**ATTACHMENT NO 1 - SCHEDULE OF SUBMISSIONS
CHINATOWN OLD BROOME PRECINCT STRCUTRE PLAN**

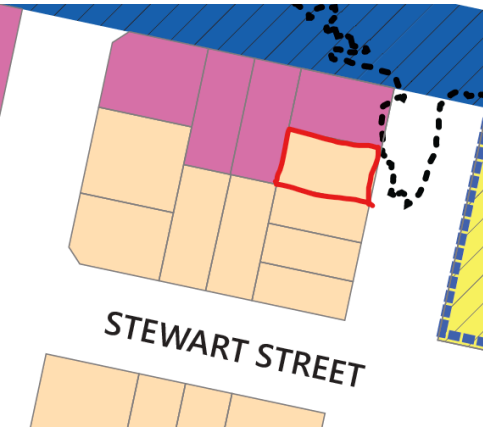
10	Andrew Grace and Sadie Prendergast	<p>I am writing to formally object to the proposed zoning change for my property at 1/3 Chapple Street, Broome, under the above-mentioned plan. Specifically, I strongly oppose the rezoning of my privately owned land from Regional Centre (R50) to Residential (R10).</p> <p>This rezoning will have significant negative implications for the use, value, and development potential of the property. The current Regional Centre (R50) zoning permits a range of</p>	<p>The Shire acknowledges the concerns raised regarding the proposed rezoning of this property from Regional Centre (R50) to Residential (R10).</p> <p>The reasoning behind this rezoning is based on the findings of the Shire’s 2017 Coastal Hazard Risk Management and Adaptation Plan (CHRMAP) and the associated risks posed by coastal erosion and</p>	<p>That the submission be noted.</p> <p>P1 – Figure 2: COBPSP - Structure Plan Map;</p> <p>P1 - Figure 5: COBPSP - Residential Density Plan;</p>

No.	Submitter	Summary of Submission	Local Government Response	Local Government Recommendation
		<p>commercial uses, which are critical to maintaining the economic viability and flexibility of the site. By rezoning the property to Residential (R10), the proposed plan removes its commercial potential entirely, limiting its use to low-density residential purposes. This change significantly undermines the property's current and future functionality, particularly in light of its strategic location.</p> <p>Furthermore, this rezoning constitutes a serious restriction on my rights as a landowner, significantly diminishing the flexibility and value of my property. The reduction in zoning density and the removal of commercial use options will adversely affect the property's economic potential. Such a change directly results in injurious affection, entitling me to claim compensation under relevant planning and compensation legislation.</p> <p>The proposed change does not appear to adequately consider the broader implications for landowners or the surrounding precinct. The loss of commercial zoning for this property contradicts the intent to foster a vibrant and functional regional hub, which relies on maintaining areas of mixed-use development.</p> <p>I respectfully request that the Shire of Broome reconsider the rezoning of my property at 1/3 Chapple Street and retain the current Regional Centre (R50) zoning. This zoning better reflects the property's current and potential use and aligns with the broader goals of promoting economic and community activity in the Chinatown precinct.</p>	<p>inundation north of Gray Street, including the area encompassing this property.</p> <p>Coastal Erosion Risks and Land Use Planning The CHRMAP identifies areas at risk of coastal processes (erosion and inundation) and provides guidance on land use planning to minimise potential future impacts on property, infrastructure, and public safety. Modelling shows that the area north of Gray Street, where this property is located, is at heightened risk of coastal processes over the medium to long term.</p> <p>The CHRMAP does not earmark this portion of Chinatown for coastal protection measures.</p> <p>The Amendment therefore sought to rezone the land to limit intensification of land uses, including higher-density residential and commercial activities, which would exacerbate the risks to both private properties and public infrastructure in the future.</p> <p>Rationale for Rezoning Rezoning these properties to Residential (R10) reflects a precautionary approach to planning, ensuring that land use intensity aligns with the identified erosion and inundation risks.</p> <p>However, it is noted that a review of the CHRMAP is being undertaken. Rezoning of the sites in advance of the CHRMAP review would be premature.</p>	<p>Figures modified to change zoning of Lot 2080 (No. 6) Gray Street, Lot 2080 (No. 6) Gray Street, Lot 2079 (No 1) Chapple Street, Lot 3 (No. 3) Chapple Street, Lot 100 (No. 6) Chapple Street, Lot 484 (No. 2) Chapple Street, Lot 10 (No 2078) Chapple Street and Lot 2077 (No 12) Chapple Street, from 'Residential R10' to 'Regional Centre'.</p>
